Purchasing Division
18 North County Street – 9th Floor
Waukegan, Illinois 60085-4355
Phone 847 377-2929
Fax 847 984-5889

ADDENDUM #2
REQUEST FOR PROPOSAL #13231
COUNTYWIDE RADIO COMMUNICATIONS SYSTEM
RFP Opening Date: OCTOBER 31, 2013, 2:00 p.m. local time

Please note the following clarifications, revisions, and/or additions to the RFP documents.

Reference FMF :LAKE COUNTY FCFD :80219 CAD :F0101080 SCALE: PRELIMINARY	Prepared (plus subject responsible if other) T.VAUGHTER Date prepared/Approved R.BOLSTAD	Date 2001/01/24	Rev PA1
	Product name HIGHWOOD ANTENNA ASSEMBLY		
	Document No AP00-SY101197V7	Sheet 1 (1)

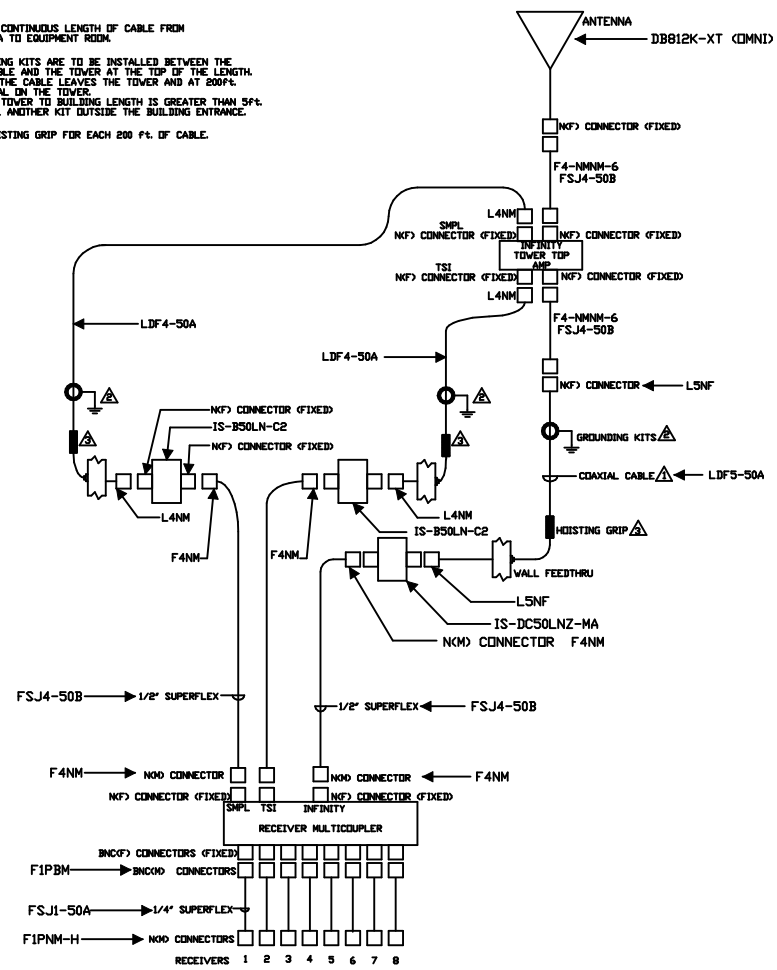
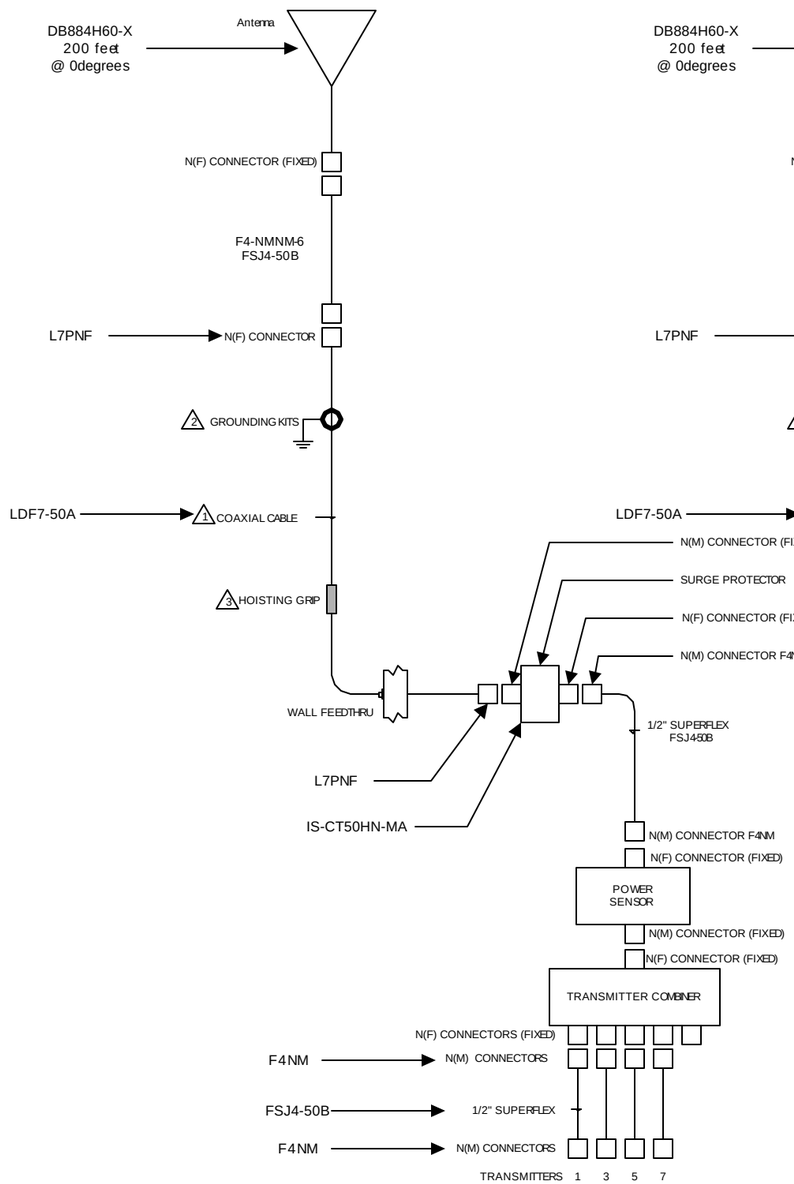
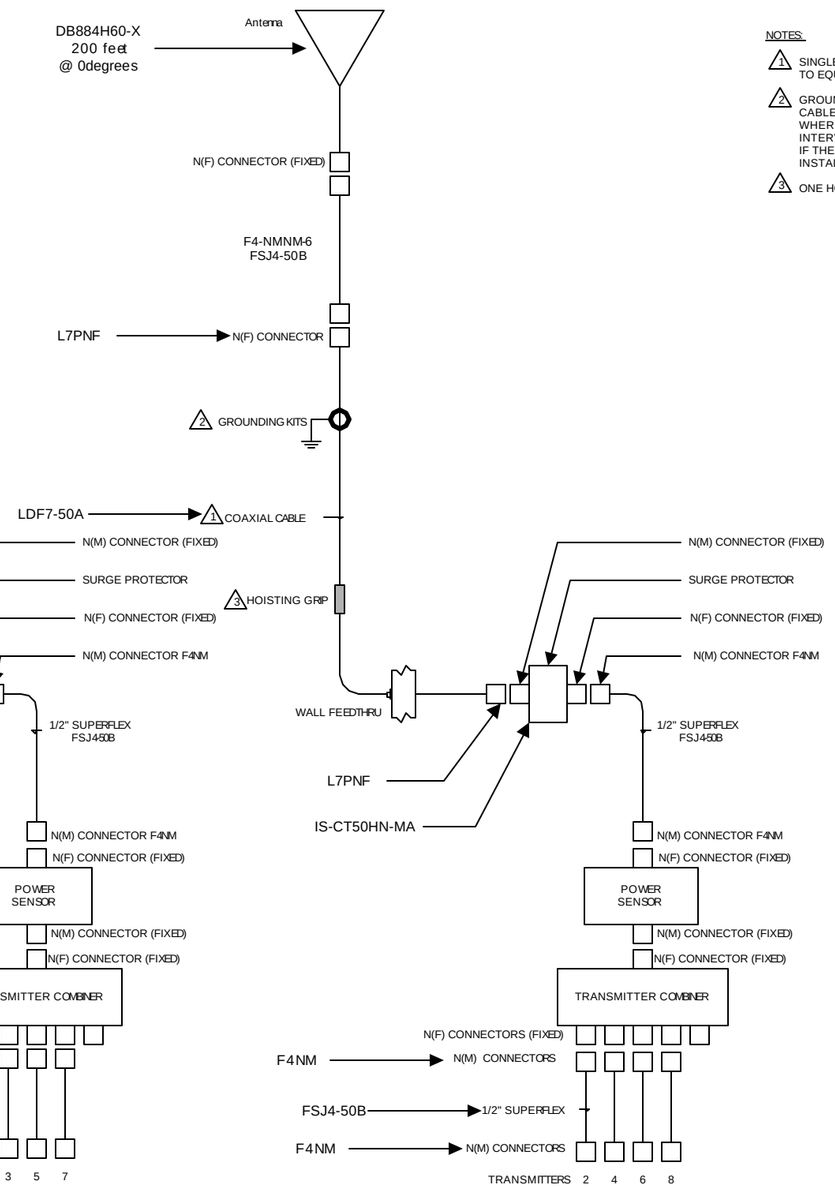
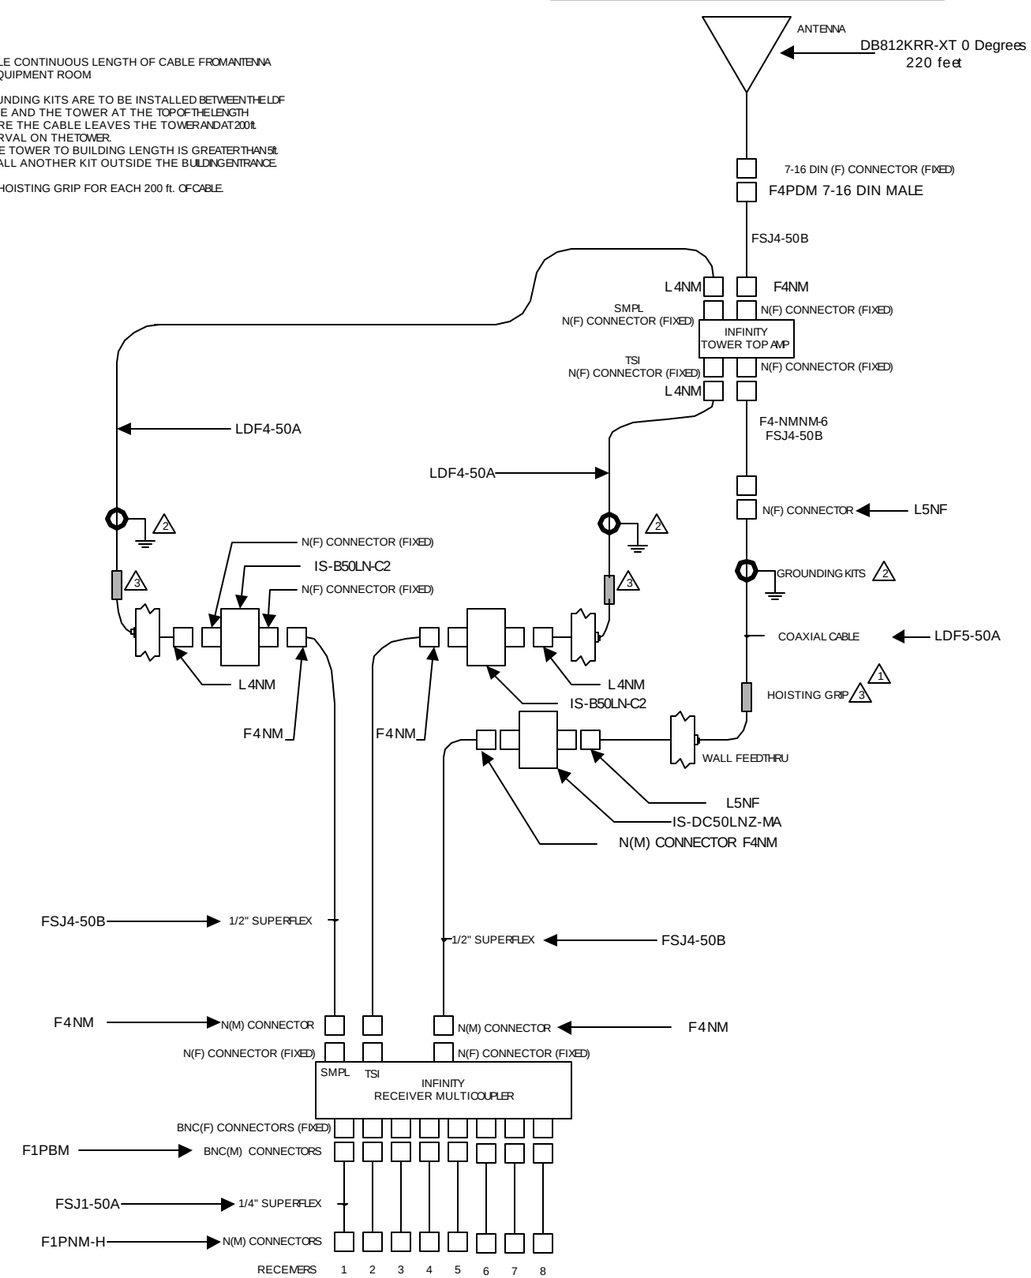
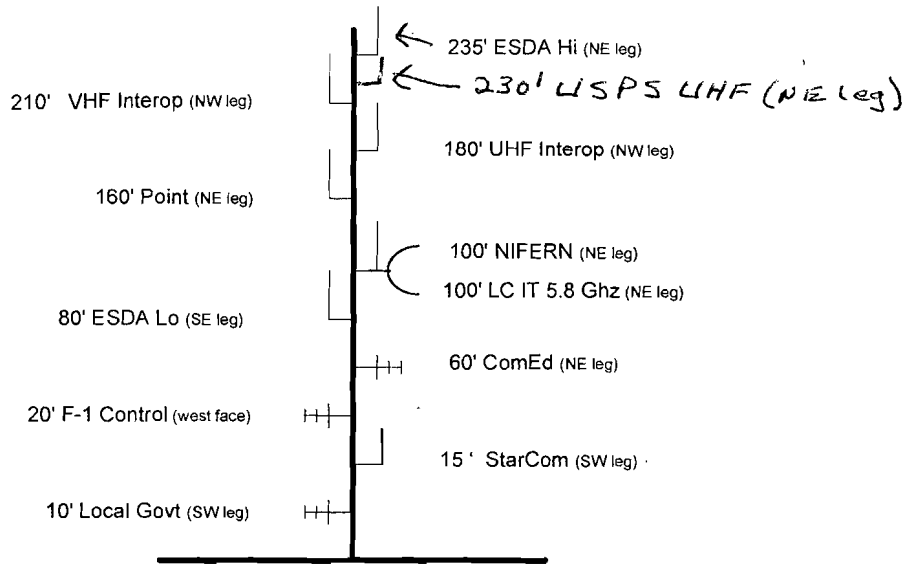
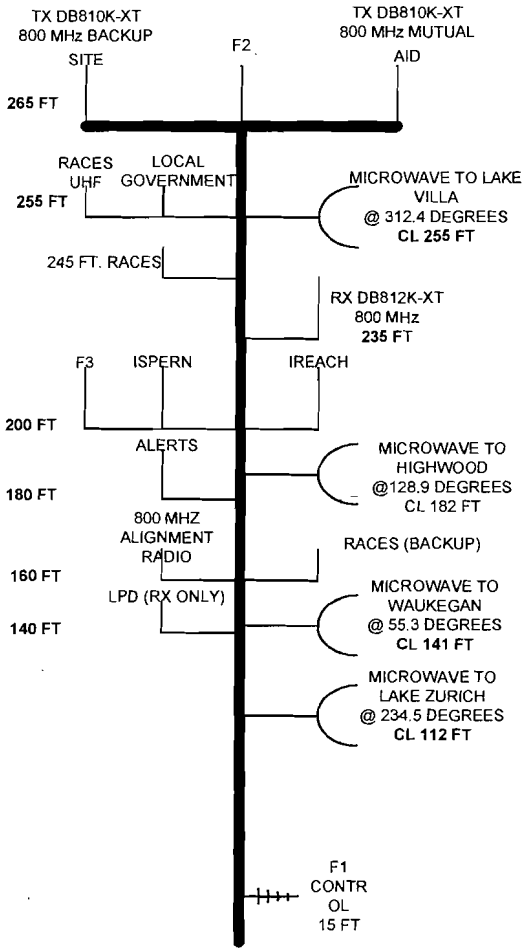
Question: Please provide information on Existing Site Antenna Heights for the RF sites.
Response: Attached are the original drawings indicating the antenna assembly at the time of system implementation.
